# **Information technology - SCSI Enclosure Services - 2 (SES-2)**

**Reference number**  
**ISO/IEC 14776-372:200x**  
**ANSI INCITS \*\*\*-200x**

# Summary of Comments on SCSI Enclosure Services - 2 (SES-2)

Figure 3 — Attached enclosure services process

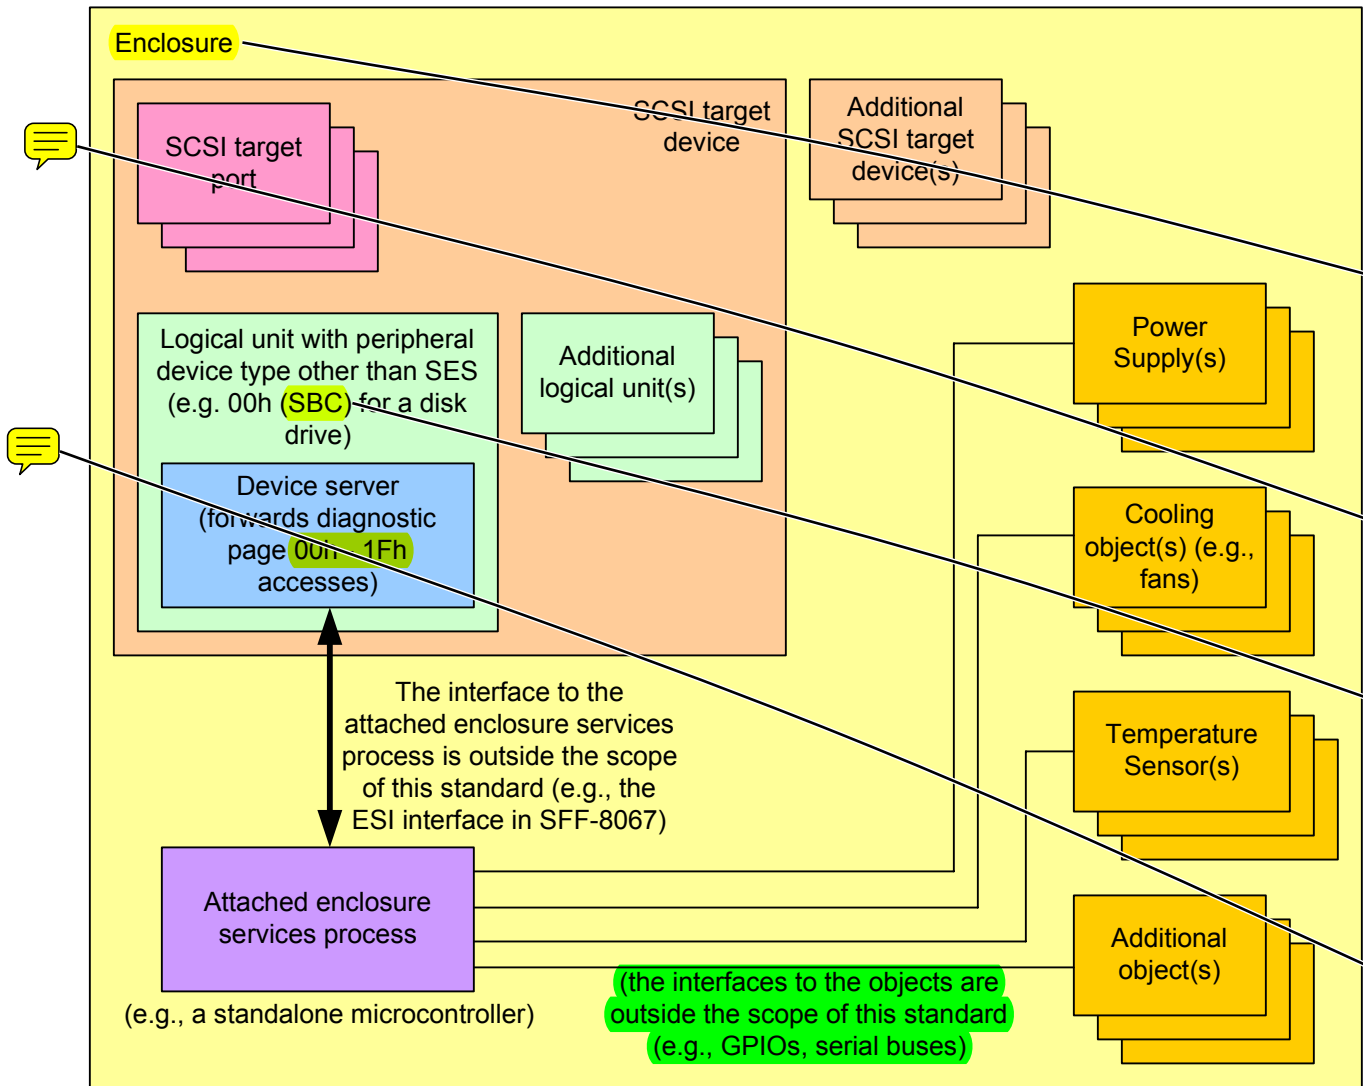
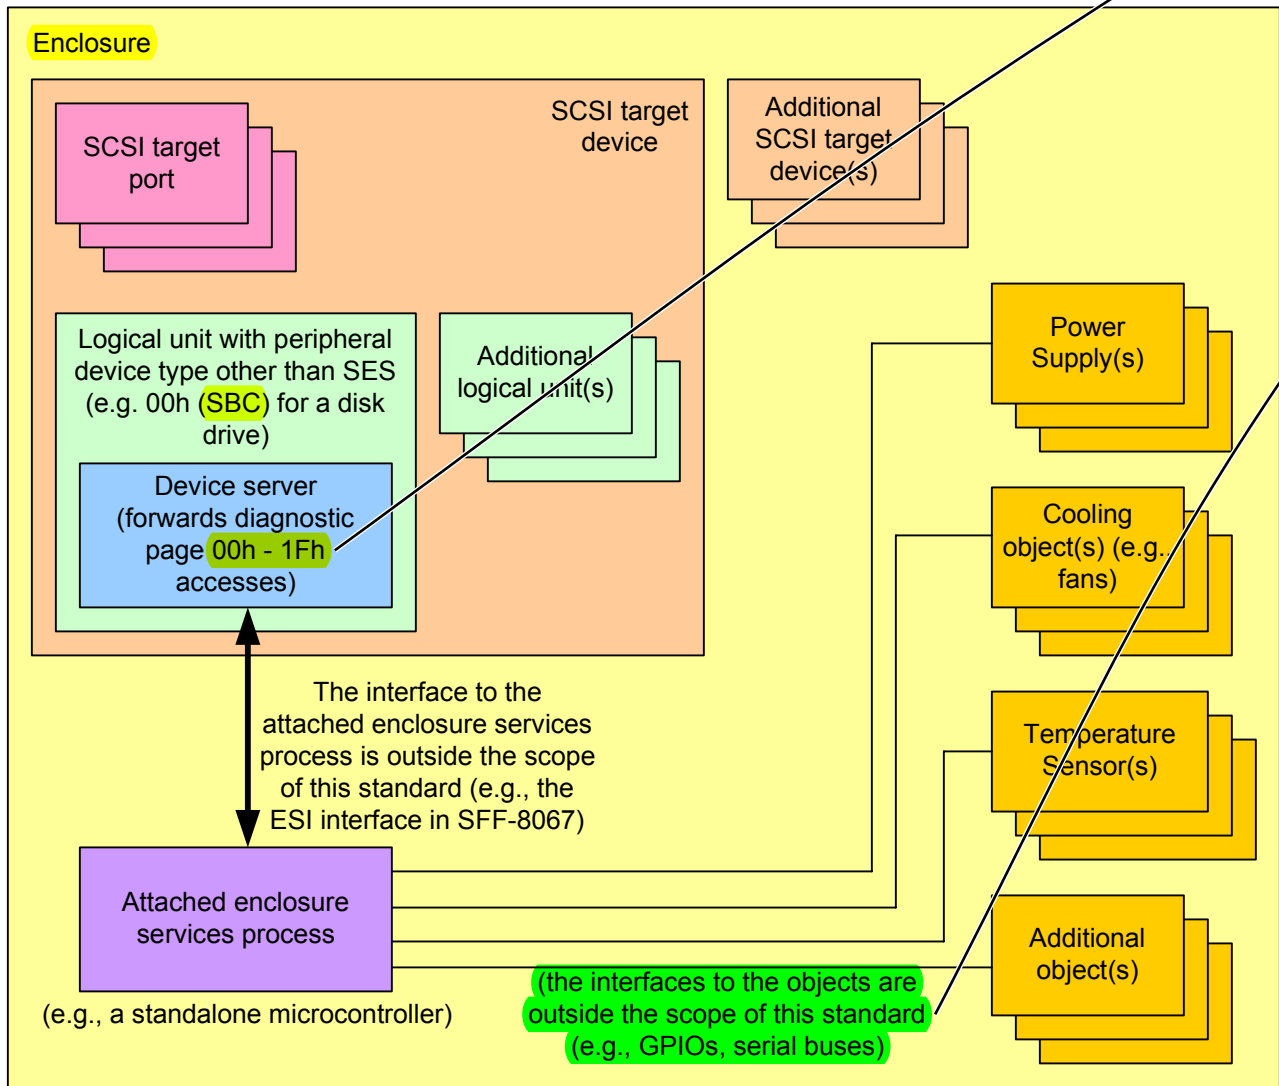
● Author: relliott  
Subject: Note  
Date: 1/2/2008 6:32:55 PM  
 Show the enclosure boundary not wholly containing the SCSI target device

● Author: symc-roger  
Subject: Note  
Date: 12/13/2007 7:25:13 PM  
 SYMANTEC 11  
PDF pg 28, pg 10, Figure 3

T Figure 3  
figure 2

**Figure 4 — Subenclosures**

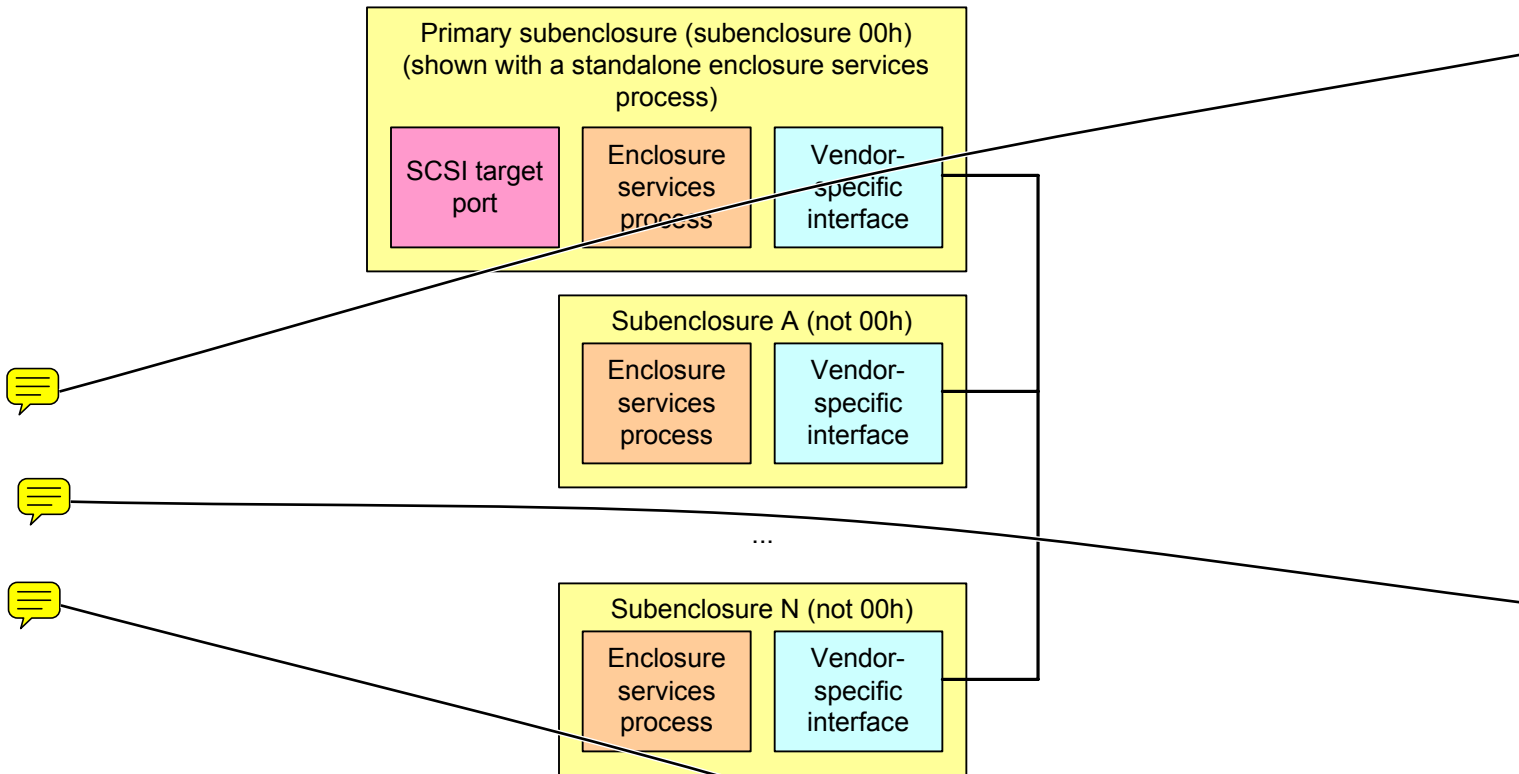
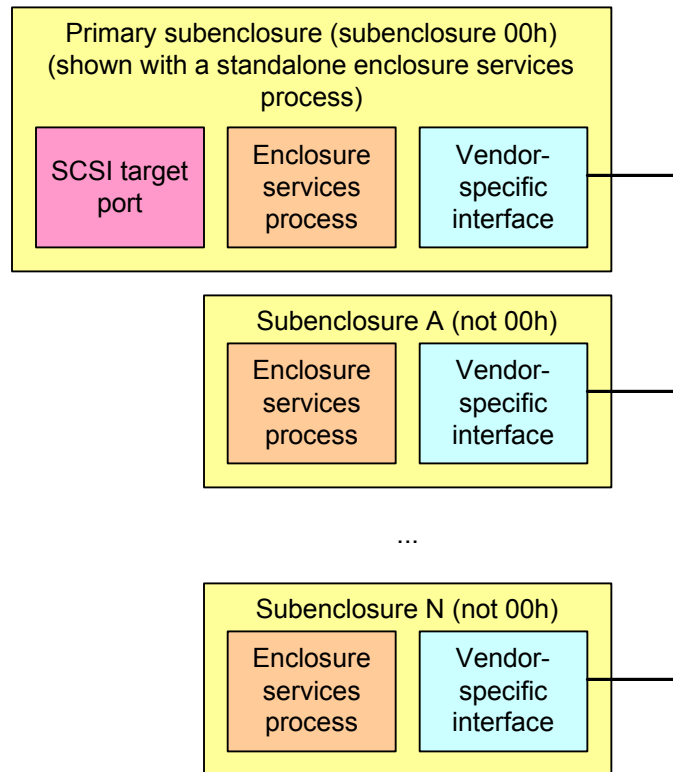
● Author: symc-roger  
Subject: Note  
Date: 12/13/2007 7:25:13 PM  
 SYMANTEC 18  
PDF pg 31, pg 13, Figure 4

The enclosure descriptor of the configuration diagnostic page supports multiple enclosure service processes per subenclosure, and this should be reflected in the figure.

● Author: symc-roger  
Subject: Note  
Date: 12/13/2007 7:25:13 PM  
 SYMANTEC 19  
PDF pg 31, pg 13, Figure 4

The figure is the only place that indicates that the subenclosure identifier of the primary subenclosure should be 00h.

Also, added a Enclosure box to the figure surrounding all the subenclosures.

added new section and new figure showing that. It's too complicated to overlay that with multiple subenclosures (which would then demand that standalone/attached be included as well).

Prepend the following sentence to the second paragraph after the figure: "The subenclosure identifier of the primary subenclosure shall be 00h."
